BEFORE THE MERIDIAN CITY COUNCIL

IN THE MATTER OF THE)	
REQUEST FOR FINAL PLAT	
CONSISTING OF 61 BUILDING)	CASE NO. FP-2025-0003
LOTS AND 11 COMMON LOTS ON)	
29.11 ACRES OF LAND IN THE R-2	ORDER OF CONDITIONAL
AND R-8 ZONING DISTRICTS FOR)	APPROVAL OF FINAL PLAT
APEX NORTHWEST #6.	
)	
BY: BRIGHTON CORPORATION)	
APPLICANT)	
)	
)	
)

STAFF REPORT

Apex Northwest No. 6

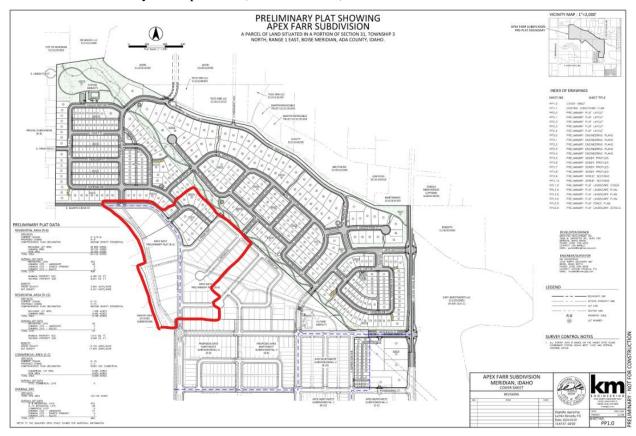
In order for the proposed final plat to be deemed in substantial compliance with the approved preliminary plat as set forth in UDC 11-6B-3C.2, the number of buildable lots cannot increase, and the amount of common area cannot decrease. However, the road alignment and lot configuration have changed slightly from the preliminary plat. This is due to the approval of Apex Farr (H-2024-0014). Since there is no change to the number of buildable lots and the amount of common open space is the same, Staff deems the proposed final plat to be in substantial compliance with the approved preliminary plat as required.

C. Final Plat (dated: 01/21/25)

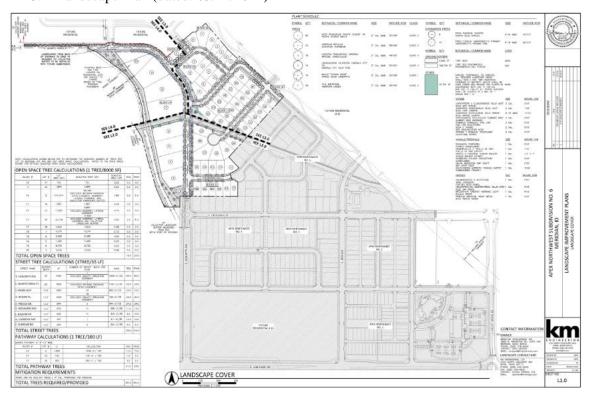
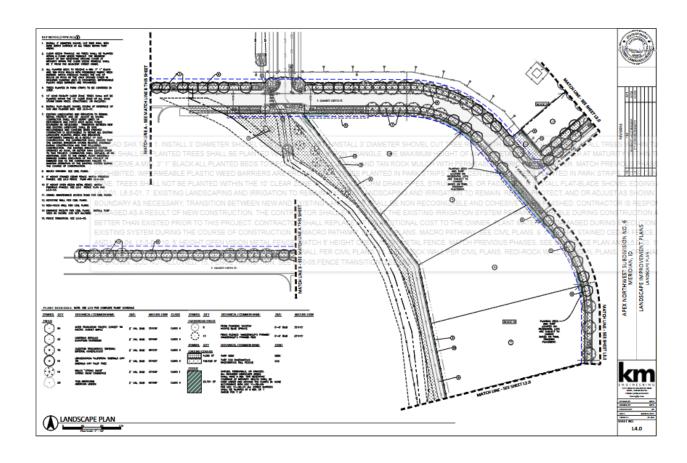
- 1. Applicant shall meet all terms of the approved annexation (H-2020-0066 (Apex); Development Agreement Inst. #2020-178120 (Apex); H-2021-0087 (Apex West); FP-2021-0056 (Shafer View Terrace); H-2024-0014 (Apex Farr); Development Agreement Inst. #2024-069485; applications approved for this site.
- 2. The applicant shall obtain the City Engineer's signature on the final plat within two (2) years of City Council's approval of Apex Northwest Subdivision No. 5 on September 10th, 2024 in accord with UDC 11-6B-7, in order for the preliminary plat to remain valid; or, a time extension may be requested.
- 3. Prior to submittal for the City Engineer's signature, have the Certificate of Owners and the accompanying acknowledgement signed and notarized.
- 4. The final plat prepared by KM Engineering, dated: 01/21/2025, included in Section V.B shall be revised as follows:

- a. Note #9: Include the recorded instrument numbers for the ACHD temporary license agreement.
- b. Note #17 and 18: Include the recorded instrument number of the ACHD permanent easement.

- c. Note #15 and 16: Include the recorded instrument number of the City of Meridian Sanitary Sewer and Water Easement.
- d. Add a plat note stating "direct lot access to S. Sublimity Avenue is prohibited except for Lots 3-10. Block 14."

- A copy of the revised plat shall be submitted with the final plat for City Engineer signature.
- 5. The landscape plan prepared by KM Engineering, dated 05/24/2024, included in Section V.C, shall be revised as follows:
